TOWN OF WELLS, MAINE
PLANNING BOARD

Meeting Agenda
Monday, March 9, 2026, 7:00 PM
Littlefield Meeting Room, Town Hall
208 Sanford Road

SCALE: 1" = 40'	APPROVED:	DRAWN BY: MJS
DATE: 12/04/23		REVISION DATE: J : 03/04/26
JOB NO: C336-22	FILE: 88 BURNT MILL BASE.DWG	SHEET: 1

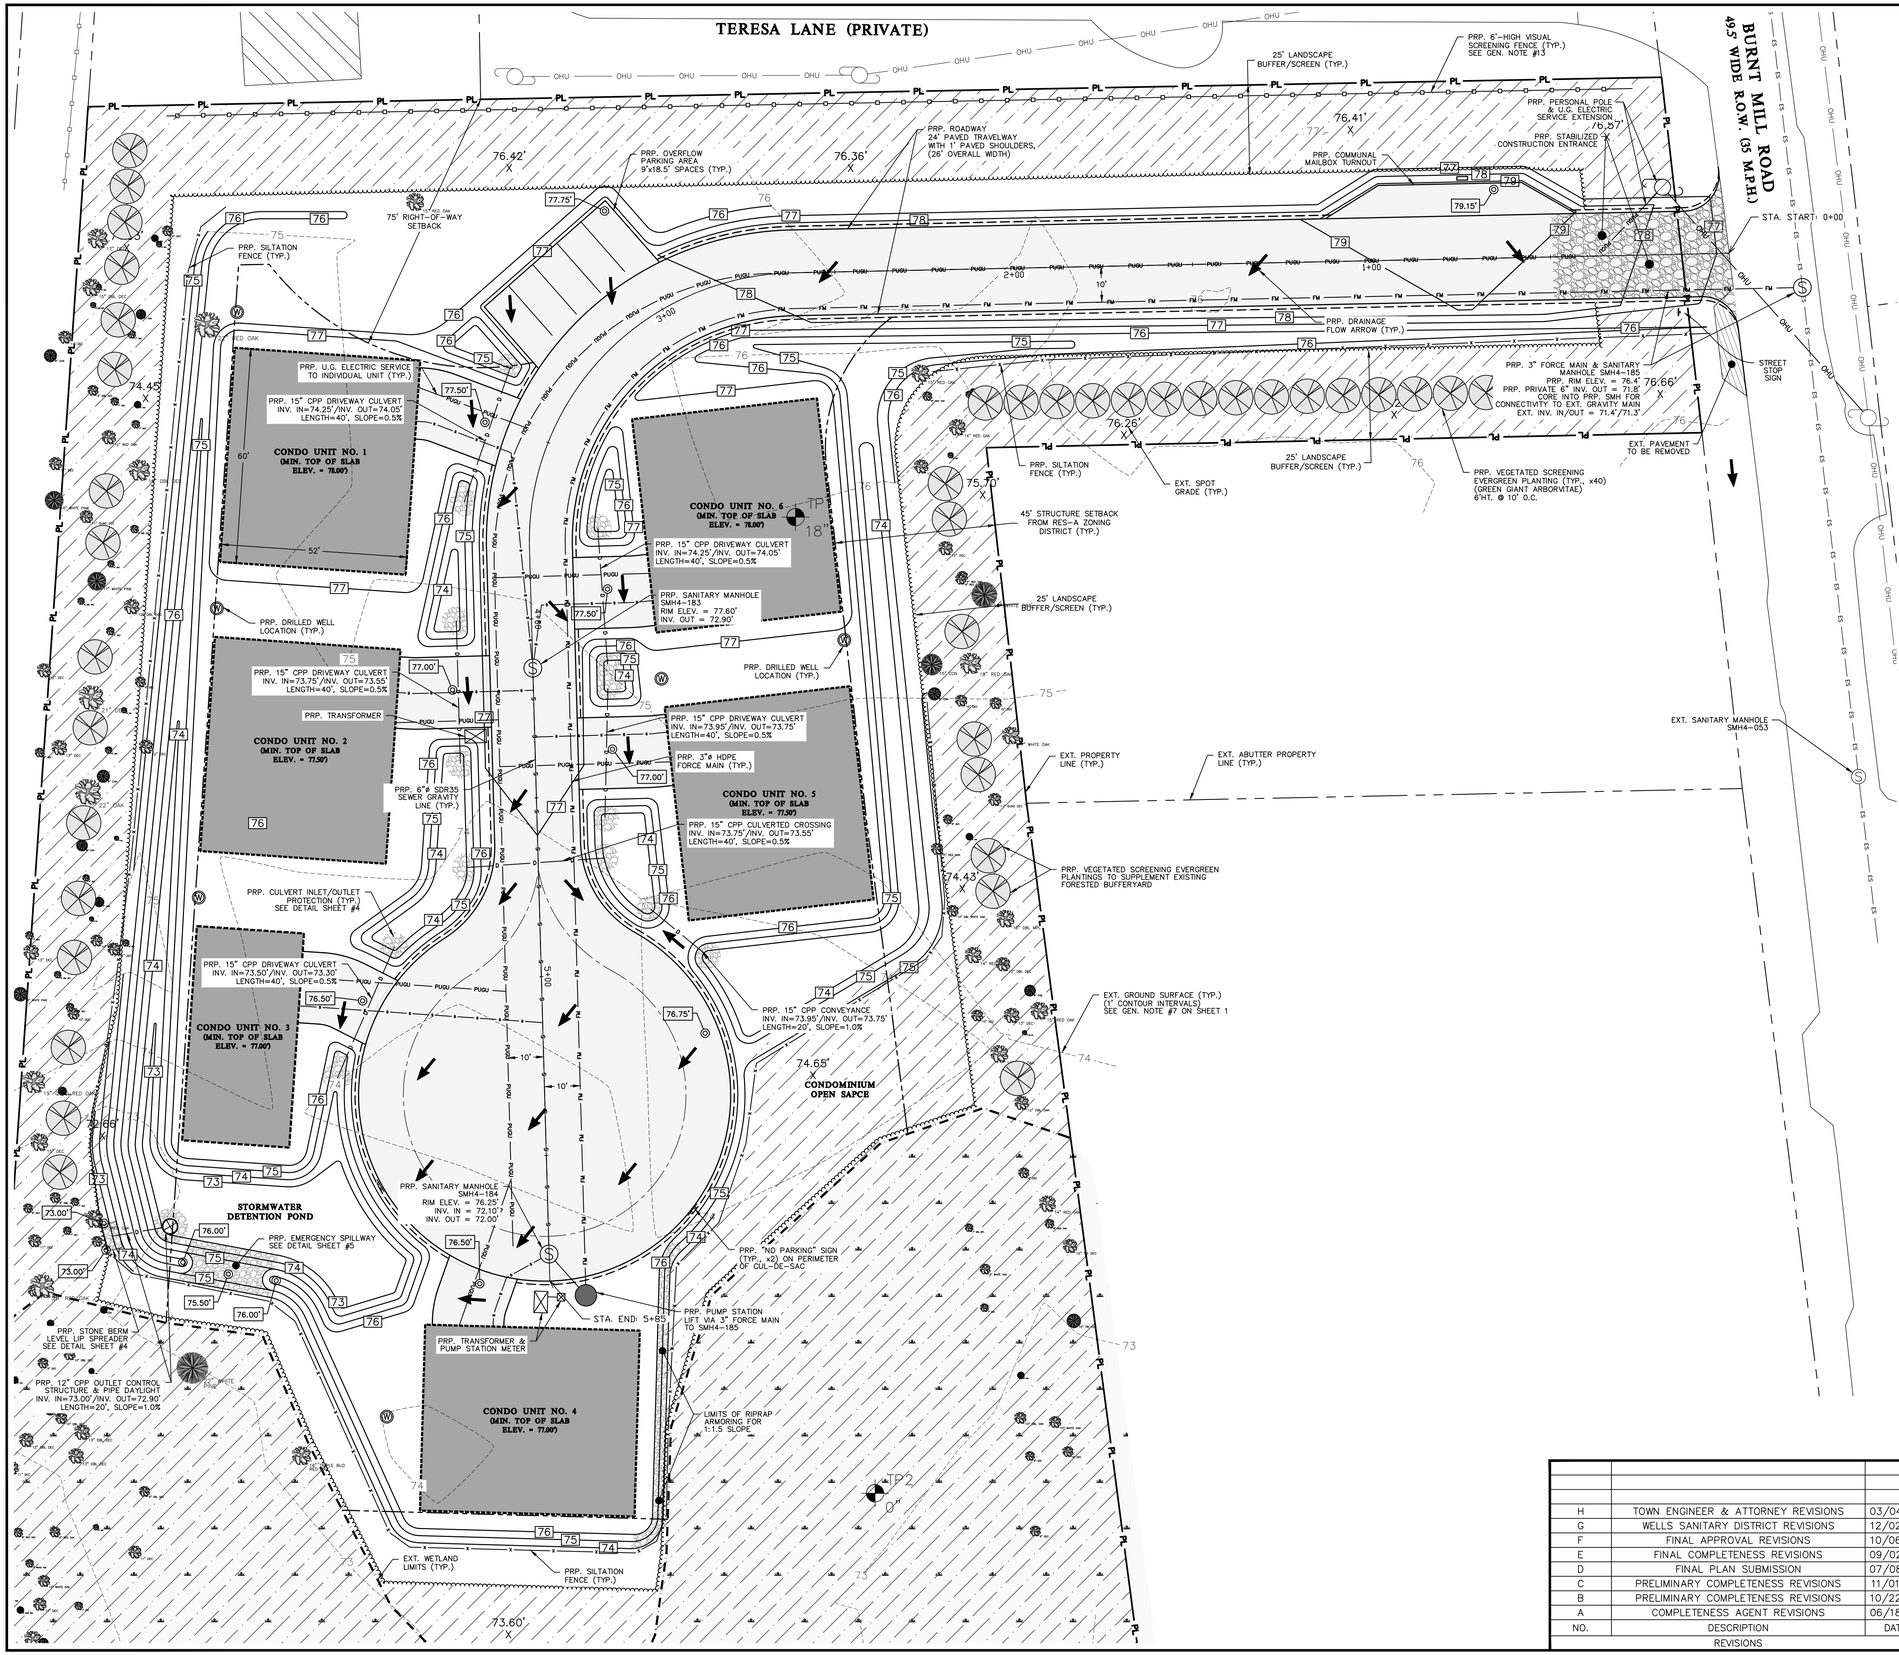
- General Note #4 on Sheet #1 has been updated to reflect the additional subtractions considered in the calculation of Residential Density for Multifamily Developments per §145-48.H.(1). These additional subtractions include the proposed overflow parking area and stormwater detention pond. The result of this updated calculation yields no change in the overall dwelling unit total, changing from 6.50 to 6.37 to keep the maximum allowable at 6 units.

- General Note #18 on Sheet #1 has been updated to include the proposed sewer system as a maintenance responsibility for the Condominium Association.

- General Note #21 on Sheet #1 has been updated to declare that a maximum of 1 Accessory Dwelling Unit (ADU) is permitted.

- General Note #22 on Sheet #1 has been updated to include perimeter screening and signage as maintenance responsibilities of the Condominium Association.

SCALE: 1" = 20'	APPROVED BY:	DRAWN BY: MJS
DATE: 12/04/23		REVISION DATE: H : 03/04/26
JOB NO: C336-22	FILE: 88 BURNT MILL BASE.DWG	SHEET: 2

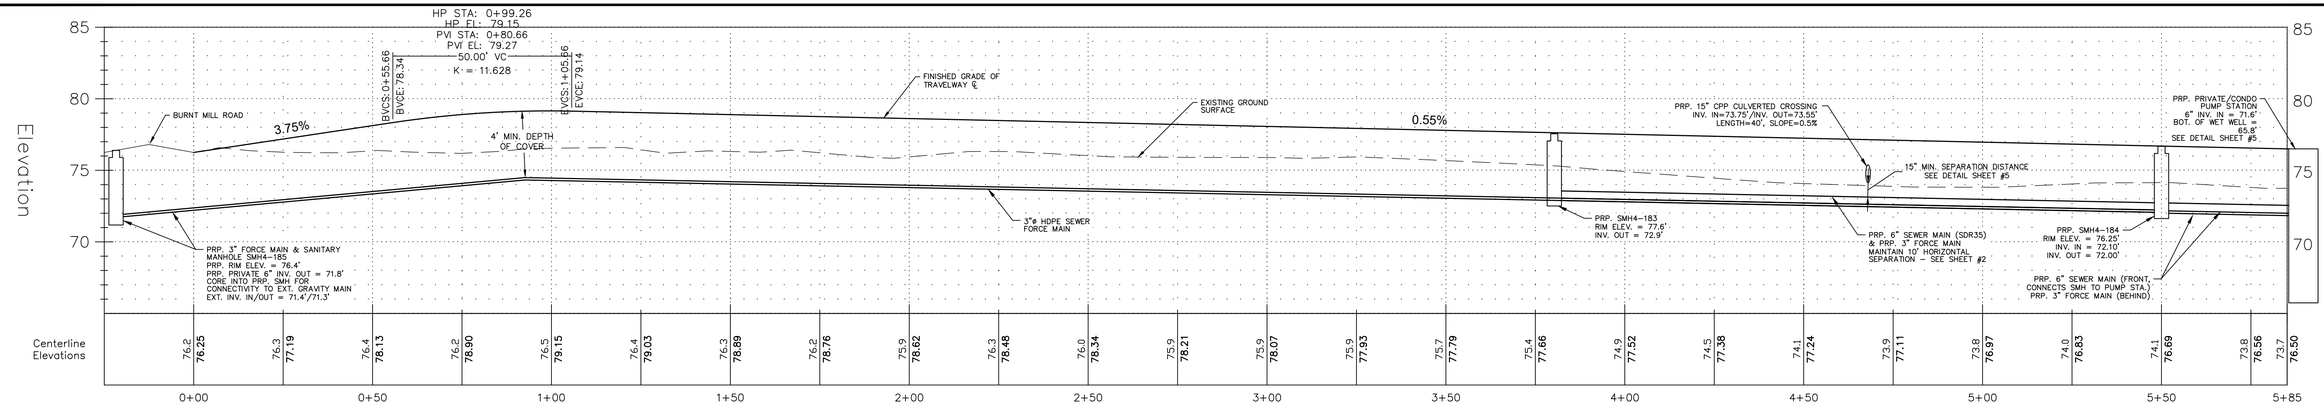
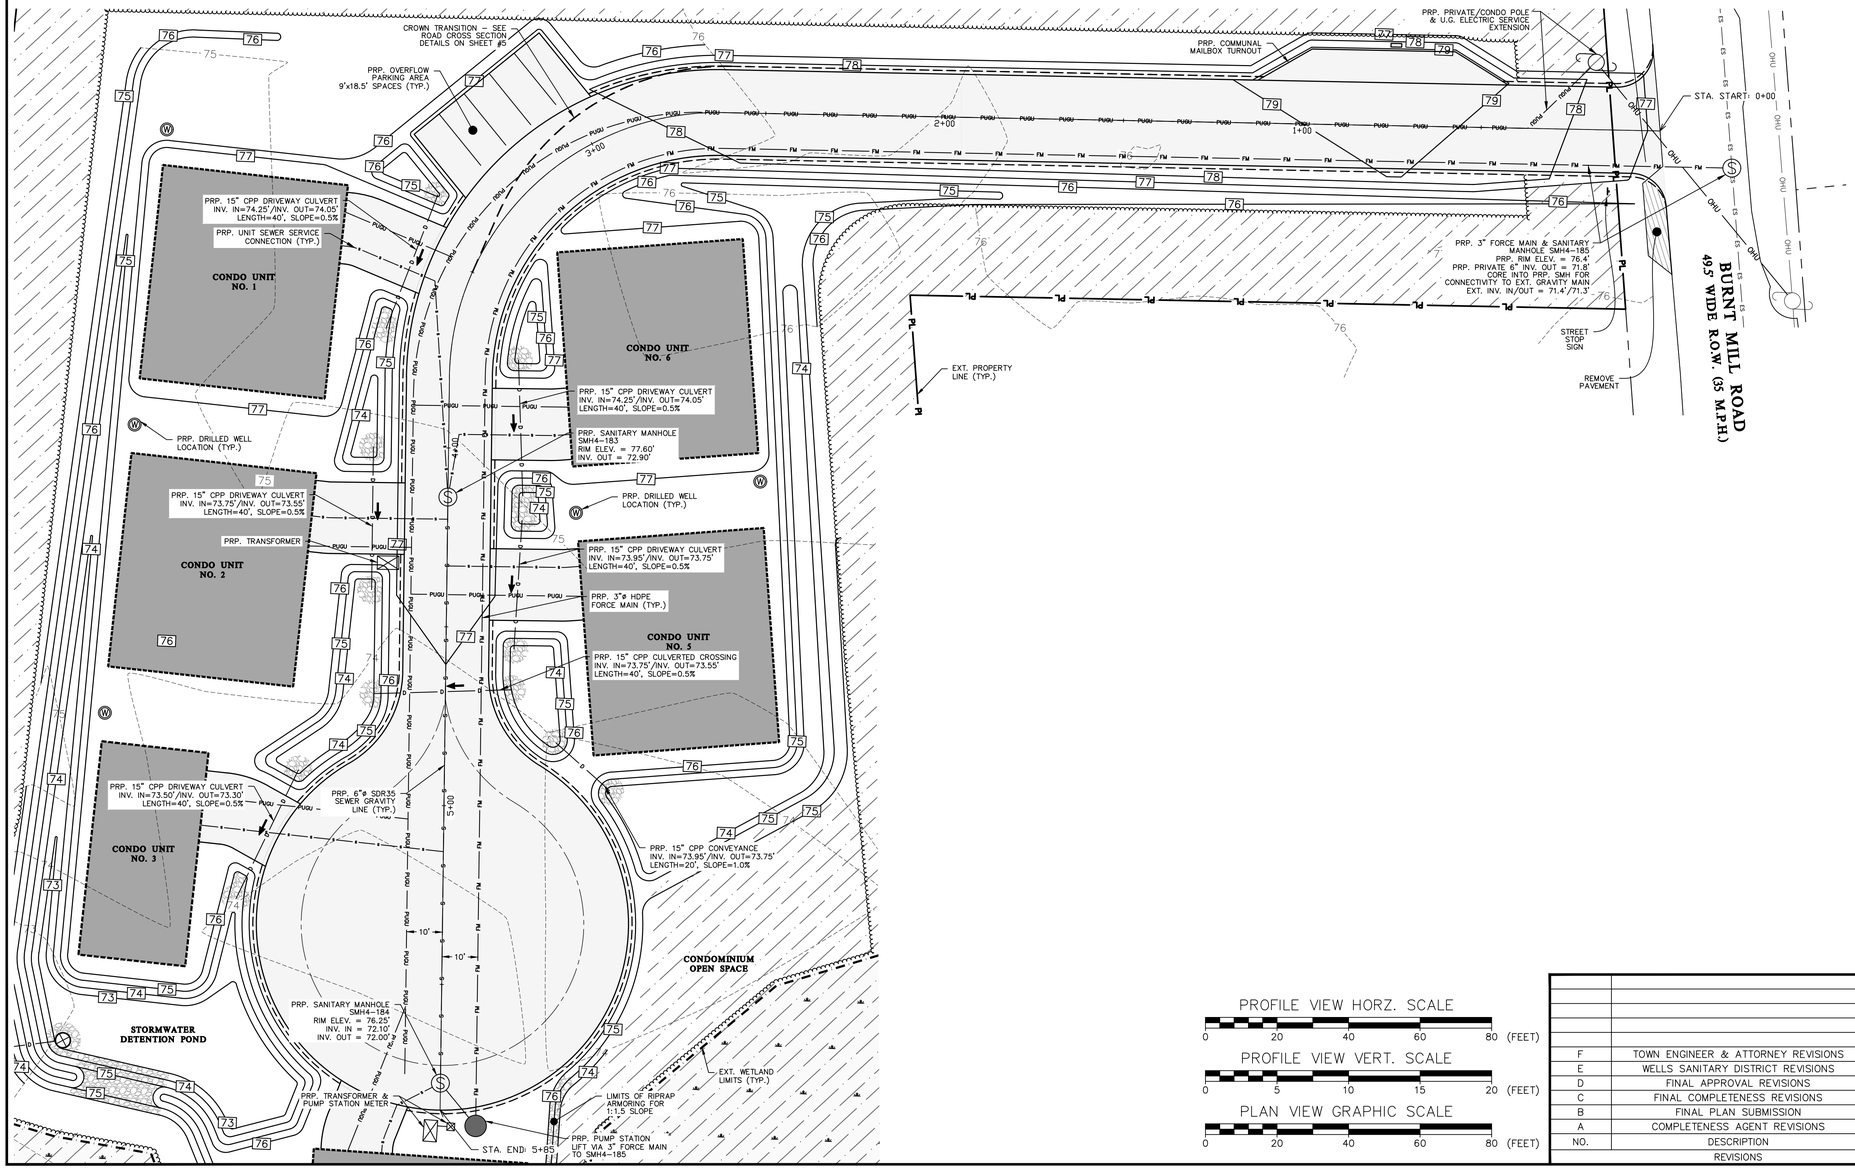
- Proposed evergreen perimeter screening depicted on Sheet #2 along the eastern sideline of the Burnt Mill Road frontage has had its required installation height changed from 4-5 feet to 6 feet as requested.

- A callout for the proposed stone berm level lip spreader at the outfall of the stormwater detention pond has been added to Sheet #2 that references the detail location on Sheet #4.
